**Re: Reason for Request – 10600 Central Avenue SW, Albuquerque, NM 87123**

**Request for Minor Amendment to Site Plan - Solar Carport Installation**

AM ENERGY  
Luminaria Senior Community  
Carport Solar PV System  
10600 Central Ave SE, Albuquerque, NM 87123

SDP1.1

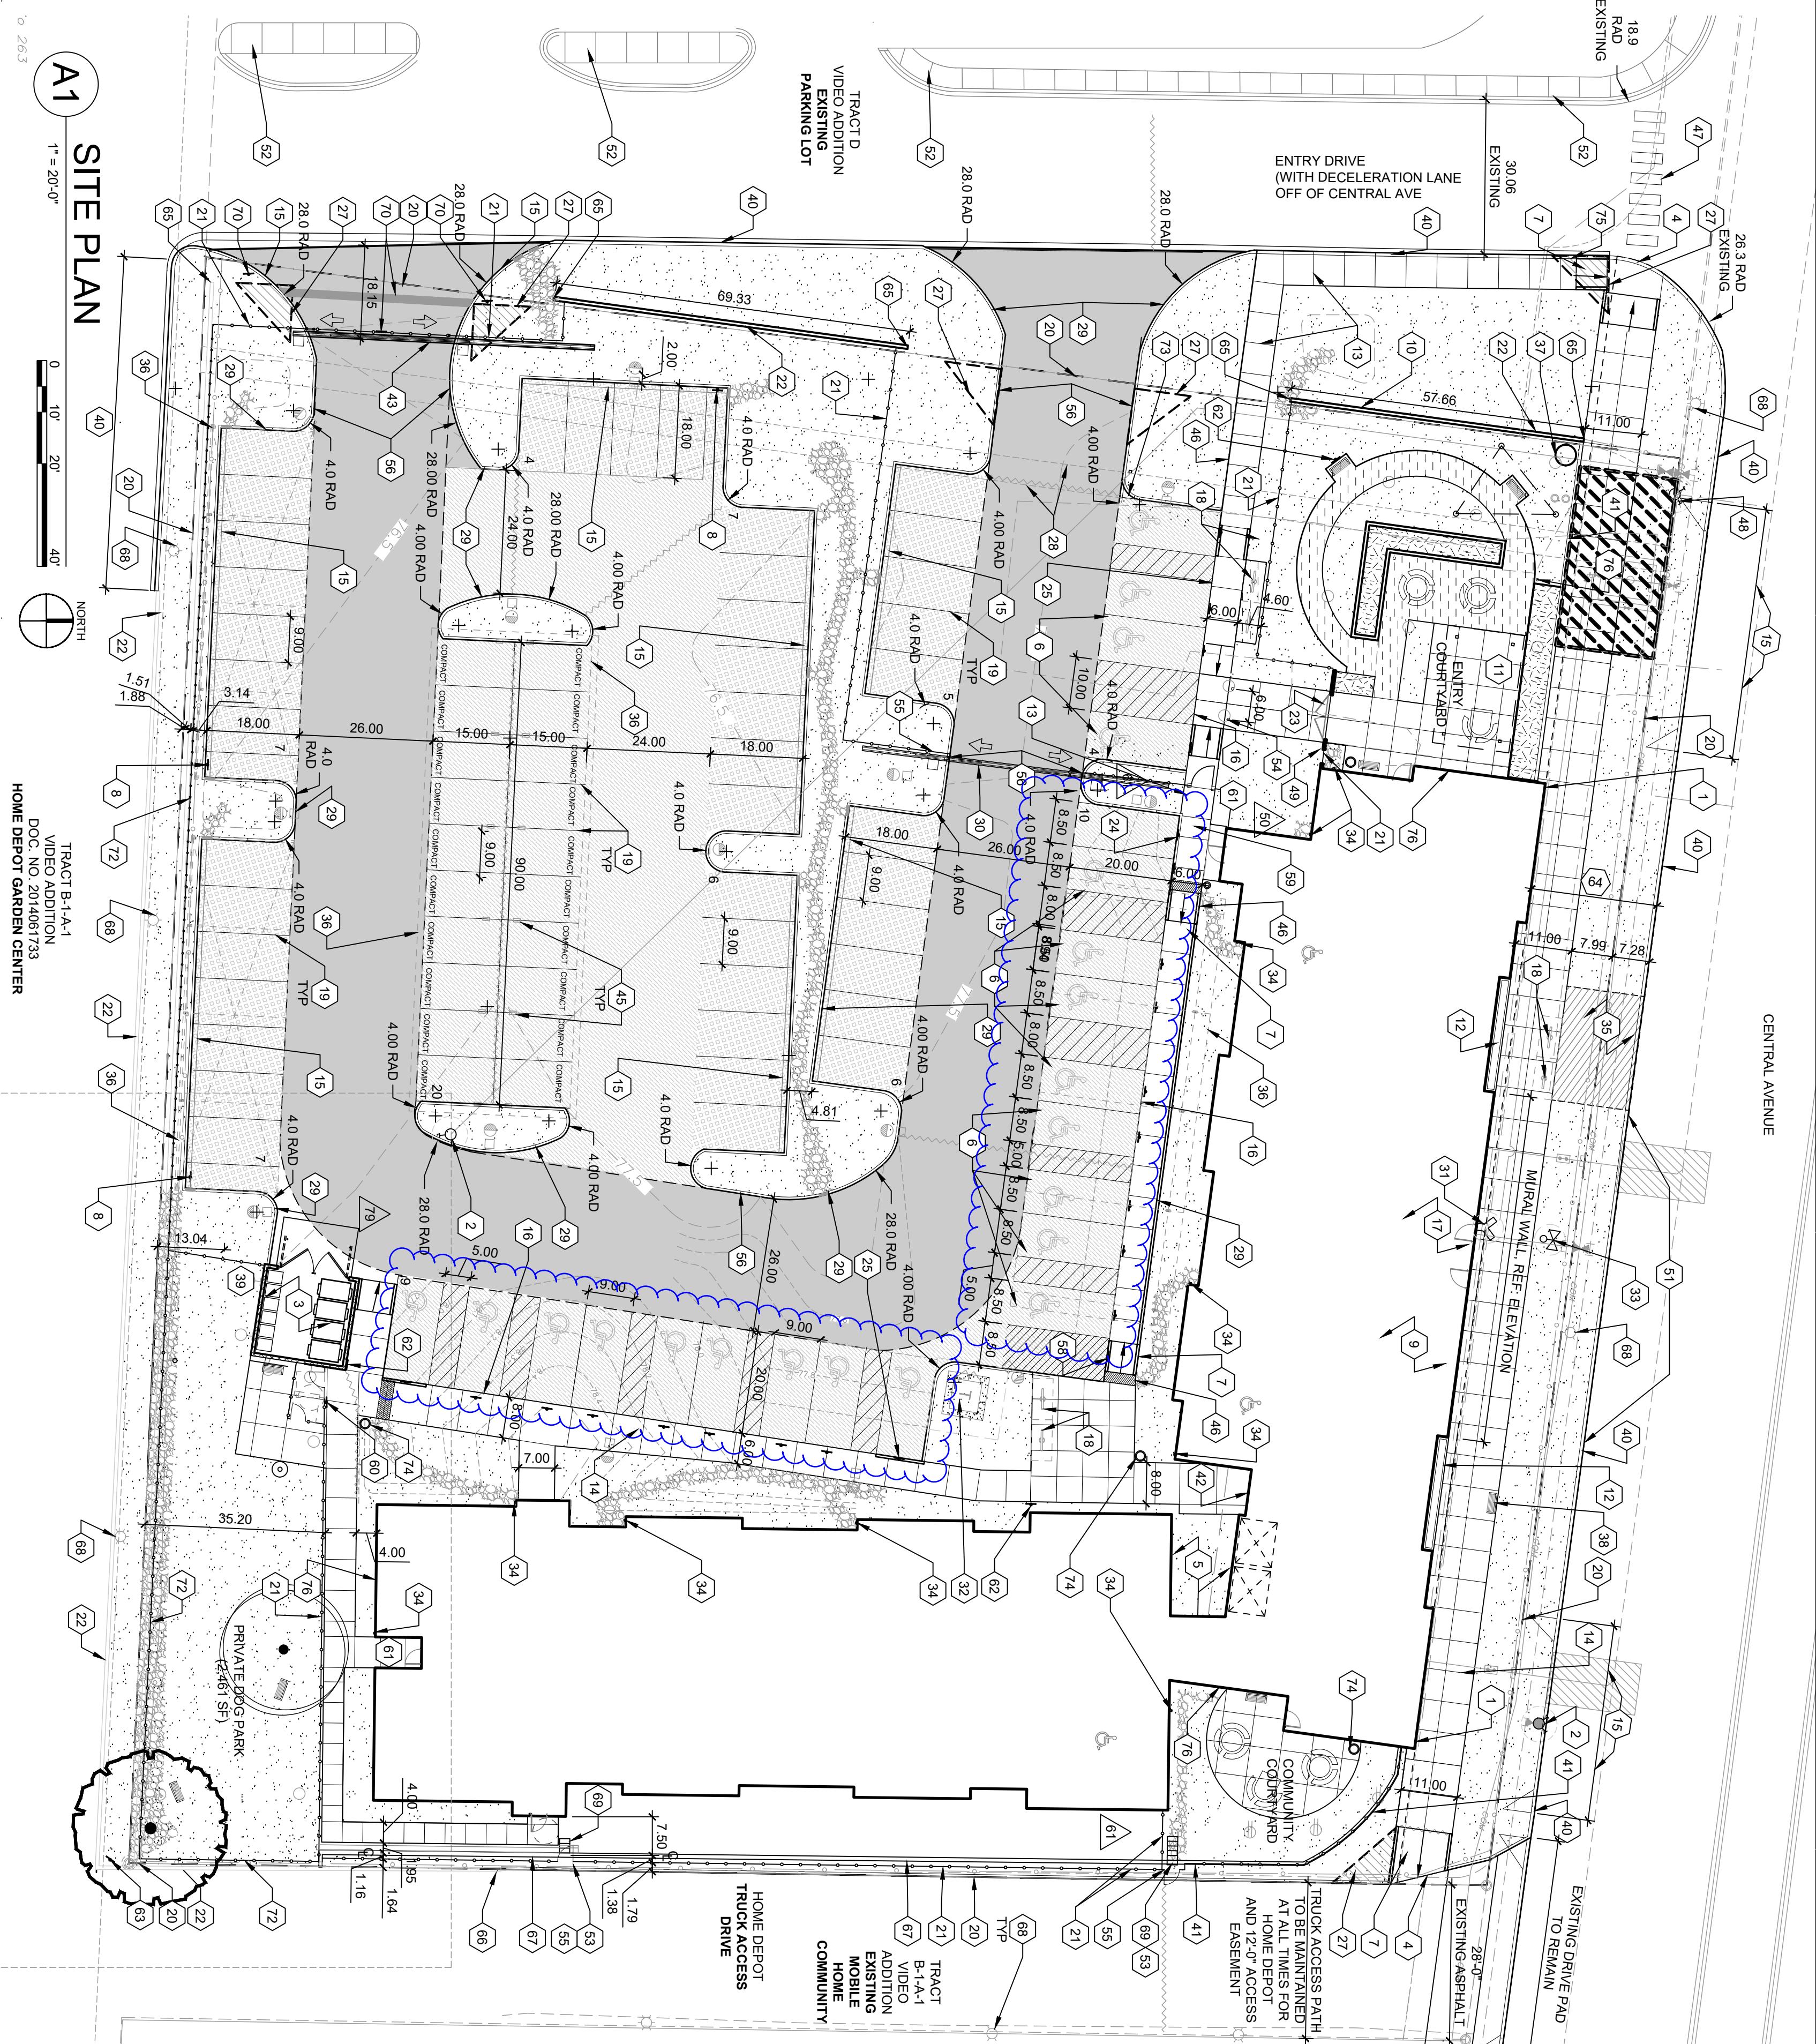
Carport 1 will be located at the North side of the parking lot over a portion (5 spaces) of the existing paved handicap parking spaces (dimensions 31'D x 84"W).

Carports 2-3 are identical will be located on the South side of the existing parking lot over (7 each) existing unpaved parking spaces (dimensions 20'D x 69"W each) and spaces will remain unpaved.

All existing parking spaces will remain usable, the existing parking space count will not change and no other modifications in the parking lot / area, other than the 3 new carports are proposed or will take place.
